Access Compliance Report

Public Rights-of-Way

(Curb Ramps)

Intersection ID: 22310	Main Street: OAK_CREEK_DR	Cross Street: SARDIS_RD	Location: S
ADA ID: 2324F1FB6060	Ramp Type: PerpDiag	Initial Pass/Fail: Fail	Overall Compliance: No
Severity Score: 33.75			
Codes/Mitigation Info/Possible Solution		Field Measurements/Component Compliance

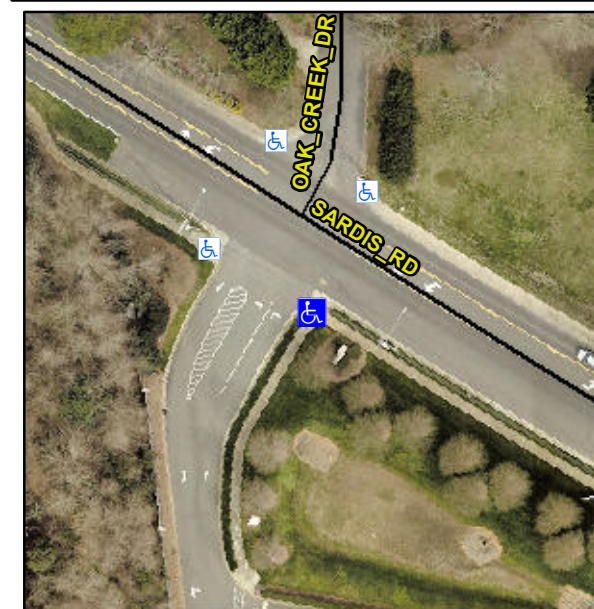
R304.5.1, R304.2.2, R304.5.3

Compliance	Description	Data	Compliance	Description	Data
N/A	Ramp Length (in)	59.0	No	Ramp Slope (%)	11.1
No	Ramp Width (in)	41.0	No	Ramp XSlope (%)	6.2
N/A	Flare Type LT	N/A	N/A	Flare Type RT	N/A
N/A	Flare Slope LT (%)	N/A	N/A	Flare Slope RT (%)	N/A
N/A	Flare Traversable LT?	N/A	N/A	Flare Traversable RT?	N/A
N/A	Landing Length (in)	N/A	N/A	DWS Provided?	N/A
N/A	Landing Width (in)	N/A	N/A	DWS Contrast?	N/A
N/A	Landing Slope (%)	N/A	N/A	DWS Length (in)	N/A
N/A	Landing X Slope (%)	N/A	N/A	DWS Full Width?	N/A
N/A	Landing Curb? (Y/N)	N/A	N/A	DWS Offset (in)	N/A
N/A	Shared Landing?	N/A			
N/A	Gutter Ponding?	N/A	N/A	Gutter Slope (%)	N/A
N/A	Gutter Lip Ht (in)	N/A	N/A	Gutter X Slope (%)	N/A
N/A	Painted X Walk1?	No	N/A	Painted X Walk2?	No
	X Walk 1 Direction	To NE		X Walk 2 Direction	To NW
N/A	X Walk 1 Width (in)	N/A	N/A	X Walk 2 Width (in)	N/A
	X Walk 1 Slope (%)	8.9		X Walk 2 Slope (%)	1.3
	X Walk 1 X Slope (%)	2.3		X Walk 2 X Slope (%)	6.7

Remove & Replace Curb Ramp With Two New Directional Ramps or Equivalent.
